PRODUCT CHANGE NOTICE

EOL/PCN25-003

RCDAT-40G-30

- Typical Insertion Loss comparison at +25 °C

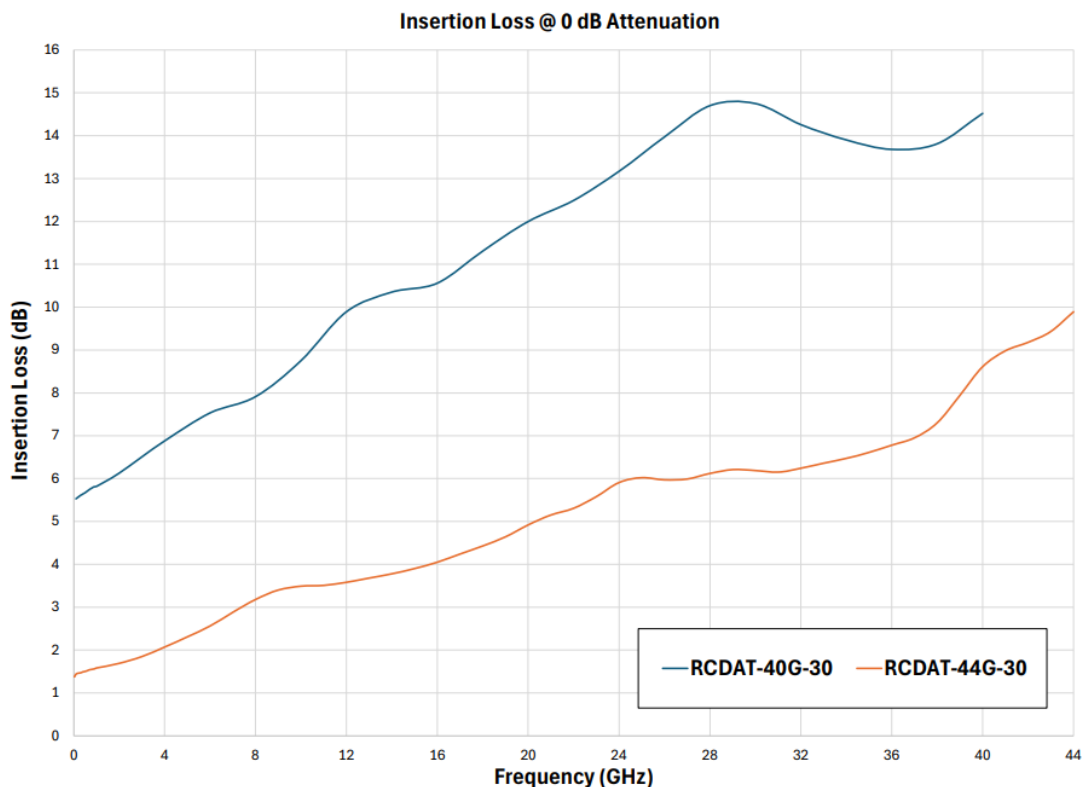
RCDAT-40G-30 obsolescence. Suggested alternative of RCDAT-44G-30 with high frequency of operation and better performance. No difference in fit or form between models.

Attribute	RCDAT-40G-30	RCDAT-44G-30
Frequency of Operation	0.1 to 40 GHz	0.1 to 44 GHz
Attenuation Range for 0.5 dB steps	0 to 30 dB	0 to 31.5 dB
Max RF Power for RF In	+35 dBm	+28 dBm
Max DC Voltage at RF port	+25 V	+10 V
